Subject: Comments to Docket No. FAA-2000-7909 - 17

We have carefully reviewed Department of Transportation Federal Aviation Administration 14 CFR Parts 25, 91, 121, 125, and 135 [Docket No. FAA-2000-7909; Notice No. 00-09] RIN 2120-AG91, "Improved Flammability Standards for Thermal/Acoustic Insulation Materials Used in Transport Category Airplanes" (issued September 20, 2000) and have several comments. These comments deal primarily with the burnthrough portion of the NPRM. They are summarized below, and explained in more detail in the discussion section of this letter.

JM results

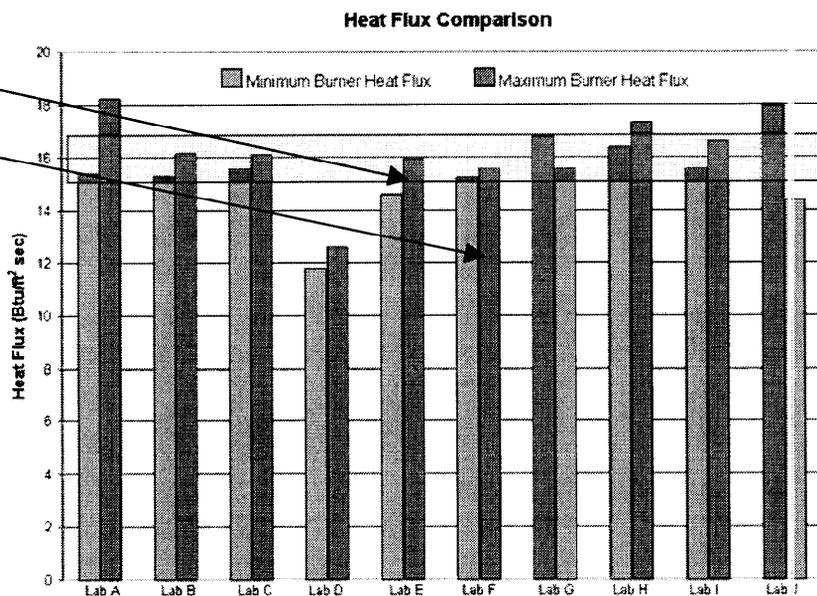
It became apparent during the first Round Robin conducted in early 2000 that despite following the calibration procedure recommended, and despite obtaining temperature profiles and burner heat flux values comparable to those at the FAA Technical Center, our burnthrough test results were vastly different. The graphs below and on the next page show the calibration and test values as they were posted on the FAA website; Johns Manville is Lab E and the FAA is Lab F.

Obviously though the equipment, set-up and calibration was similar, there is a large variation in the test results. Despite efforts to correct this variation with the help and advice of FAA Tech Center personnel, burnthrough results from the Johns Manville Technical Center continued in this manner during Round Robin II:

RRII Material 1 Comparison

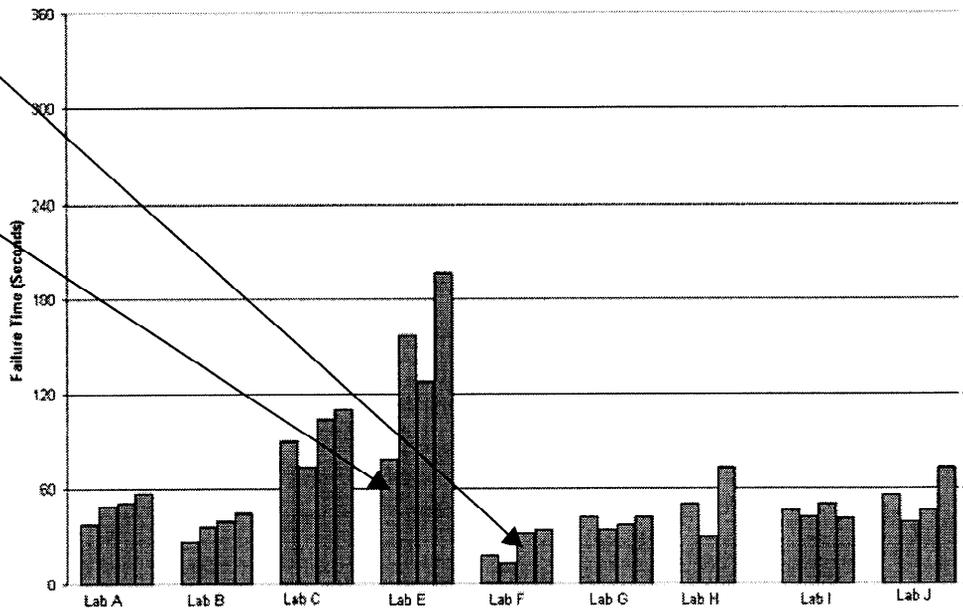
Based on the data generated, there appears to be some other parameter that affects the burnthrough test result that has not been identified. The obvious difference between our fire laboratory and the others involved in this program is the altitude of the respective fire laboratories. The fuel and air flow levels prescribed for use in this test method are, by FAA design, out of stoichiometric balance. The 6 gallons per hour fuel flow with 2150 fpm air flow is operating at 39% air deficiency for perfect combustion at standard sea level conditioned air. Due to the lower oxygen content in the air at 5,280 feet above sea level, this deficiency of combustion air becomes 49%, which results in a reduction of available heat from Jet A fuel of over 15%.

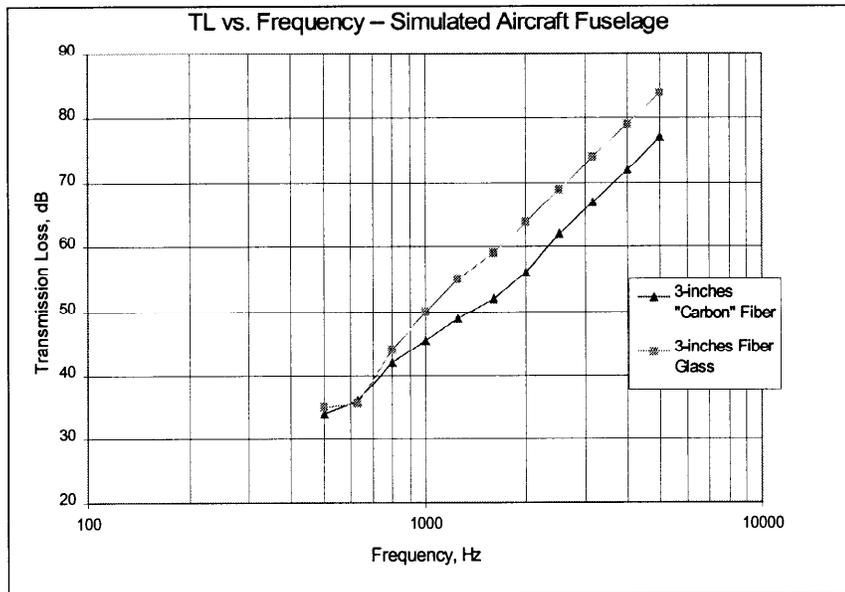
In addition, the NPRM states that "Because Curlon® and fiberglass are comparable in weight, there would be no weight penalty associated with Curlon's® use." (see page 56998). This statement does not take into account the acoustical requirements of the insulation blanket, which is the primary reason for its presence in airplanes.

Acoustical test data is graphed below, showing the transmission loss performance of three 1-inch layers of 0.42pcf AA fiber glass in a simulated aircraft fuselage, vs. the performance of three 1-inch layers of "carbon" fiber similar to the lofted Curlon product at 0.35pcf. **Note that higher transmission loss values result in lower interior cabin noise.** Transmission loss differences of 1dB are considered significant in the design of an airplane's acoustical package.

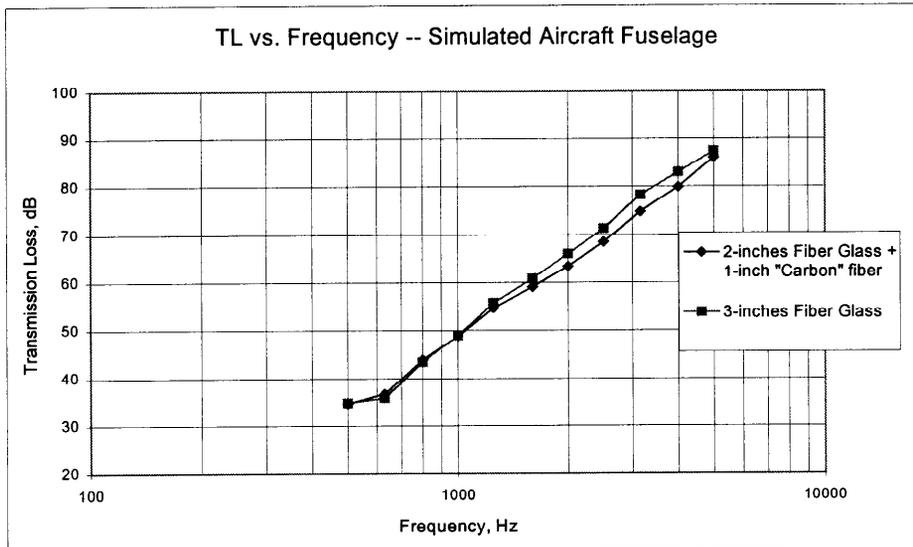
The graph below shows transmission loss data when just one layer of Premium AA fiber glass is replaced with a layer of the larger diameter "carbon" fibers. Again, 1 dB is significant; at some frequencies critical to speech interference, 2000Hz for example, the difference is more than 2.5dB.

Although the Curlon material tested acoustically is not the exact same material being produced currently, the fiber diameters and airflow resistance of the current product are comparable. Acoustically they would be expected to perform in a similar manner. In order for the system utilizing this product to provide an equivalent level of acoustical protection to current blanket designs, further insulation and weight would have to be added.
